Product Change Notification

Document No. **PCN-A-20241213** **Revision** **1.0**

W15L100-PTA3-ME upgrade new medical certificate IEC 60601-1: 2005/AMD2:2020, and also add additional USB type-C port as optional

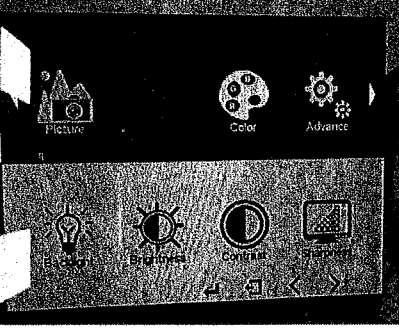
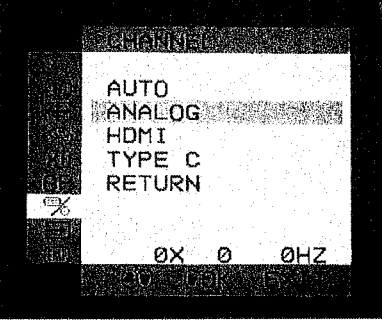
1. Upgrade new Main board
2. Additional USB type-C port as optional
3. Upgrade the OSD navigation Menu

Original	New
I/O Port	<p>USB for Touch Screen x1 VGA x1 HDMI x1 Audio in x1</p> 	<p>USB Type-C x1 (Alt mode 5V/3A) USB for Touch Screen x1 VGA x1 HDMI x1 Audio in x1</p> 
OSD Menu Screen
